HYDROGEOLOGIC EVALUATION
OF THE
PONCE CENTER FOR ENVIRONMENTAL CONTROL SITE
PONCE, PUERTO RICO

Prepared for:

U.S. Environmental Protection Agency
Region II
New York, New York

13 August 1984

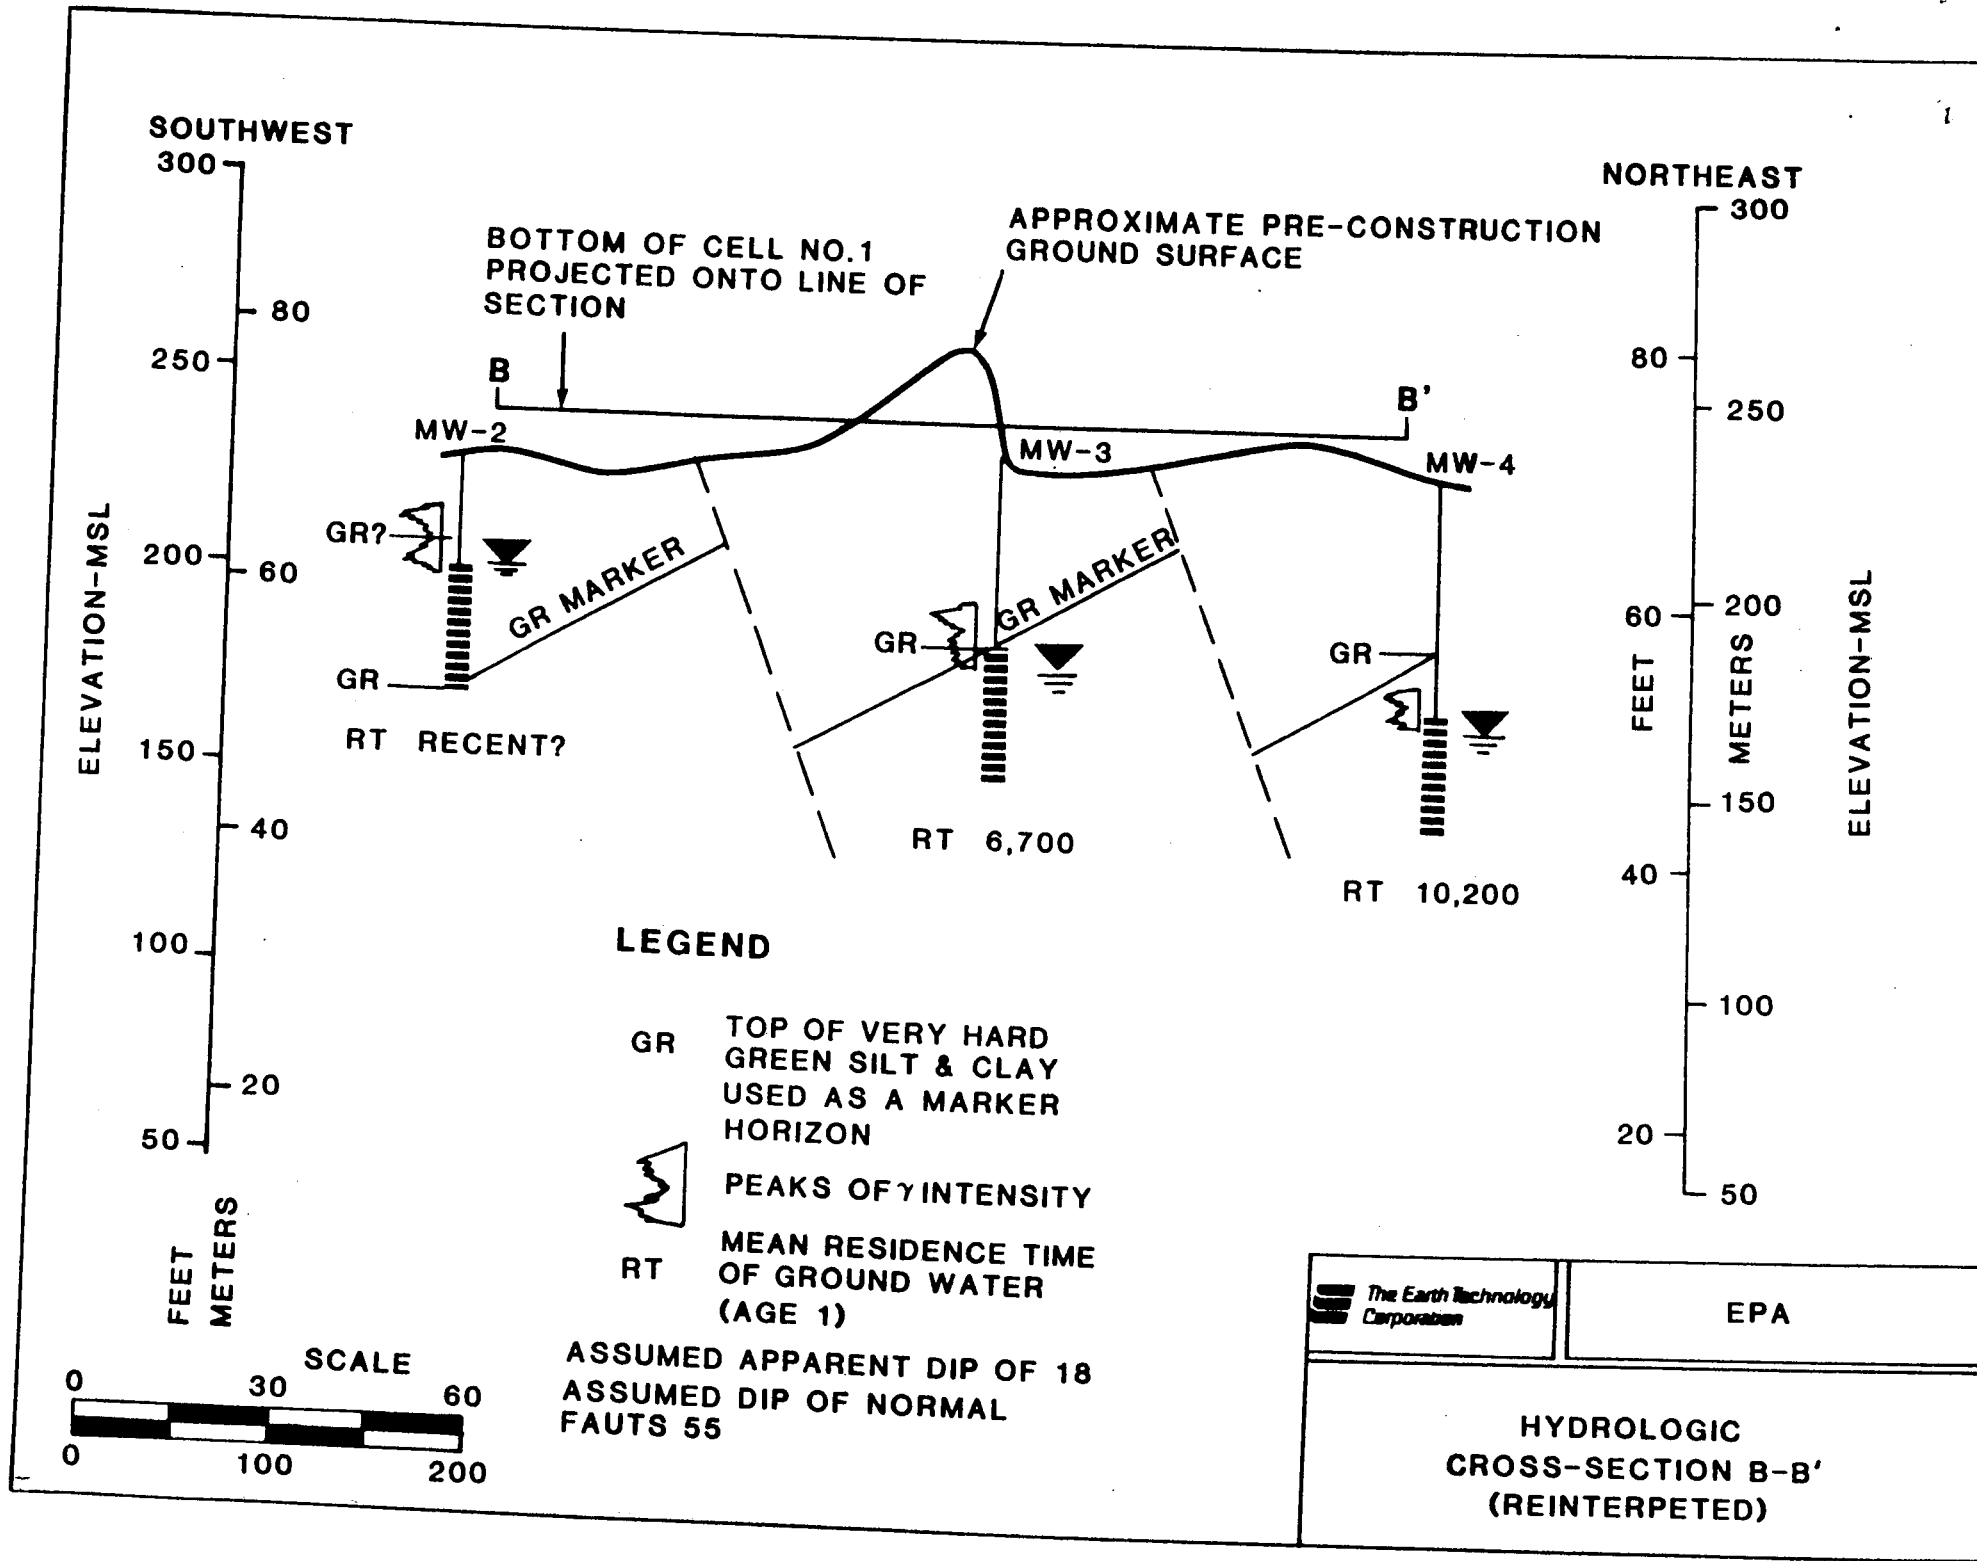
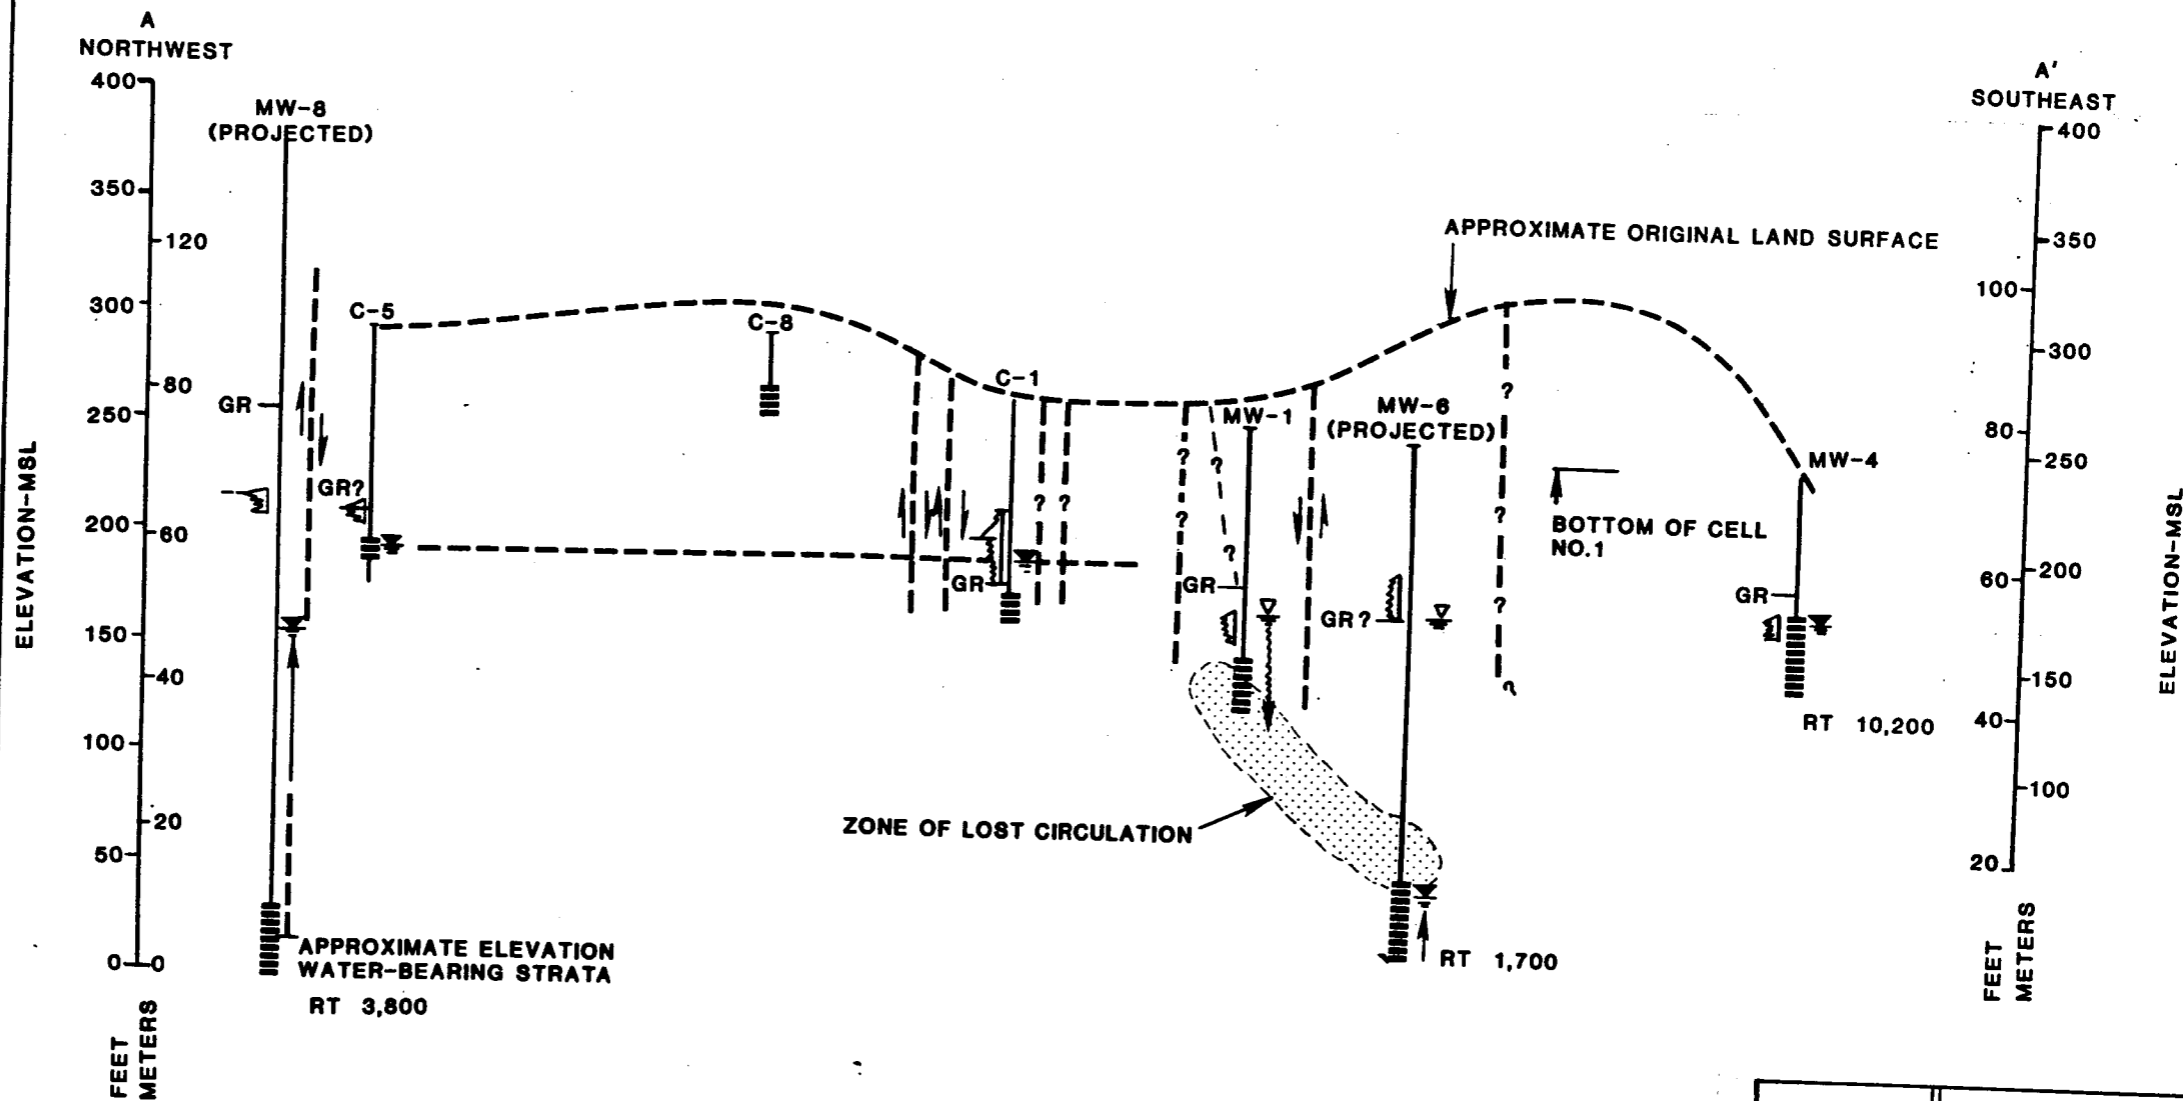
The reviewer has made an attempt to draw hydrogeologic sections (see attachments), more detailed than the sections presented in the application. Available borehole logs, gamma-logs, surface geology and ground-water data were used in preparation of the sections. The top of dark green Juana Diaz material was used as a stratigraphic marker, together with gamma-log peak intensity (an indication of higher clay content).

The sections are meant to illustrate the complexity of Ponce site hydrogeology and tectonics. Every borehole seems to define its own tectonic block. It is felt the proposed interpretation is still sketchy, open to debate, and subject to major changes when new exploration data becomes available. (The ability and ease to draw geologic/hydrogeologic sections is a simple criterion to determine if the current information is sufficient to characterize the site geologic and hydrogeologic conditions. The Ponce site is still underexplored if this criterion is used.)

- o Drilling of a monitoring well may alter the original ground-water condition and create pathways for ground-water movement between blocks. This may be the case with MW-1, where the screened interval created a pathway for water movement (see cross-section).

Abnormal behavior of the graph for MW-1 is very distinct and indicative of more than one water-bearing zone in the well vicinity. Drilling and screening of MW-1 partly in a more pervious fracture zone (fluid loss) appears to have resulted in drainage of water from the upper zone down through the fracture zone which was detected also in MW-6 (see Section A-A').

An association of shallow-water levels with the top of green shale and peaks of gamma intensity is a striking feature on the attached cross-sections. This may suggest some degree of stratigraphic control of ground-water occurrence at shallow depths; however, this hypothesis requires further understanding and refinement.

When the top of the green shale is reached while drilling a monitoring well, drilling should progress with special care, possibly with frequent stops to determine the presence of a ground-water zone. It is likely (see sections) that either MW-6 missed the water zone, or water from the zone had been drained by MW-1. The same might have occurred in MW-8. (In order to prevent further communication between two water-bearing horizons, well MW-1 should be grouted.)
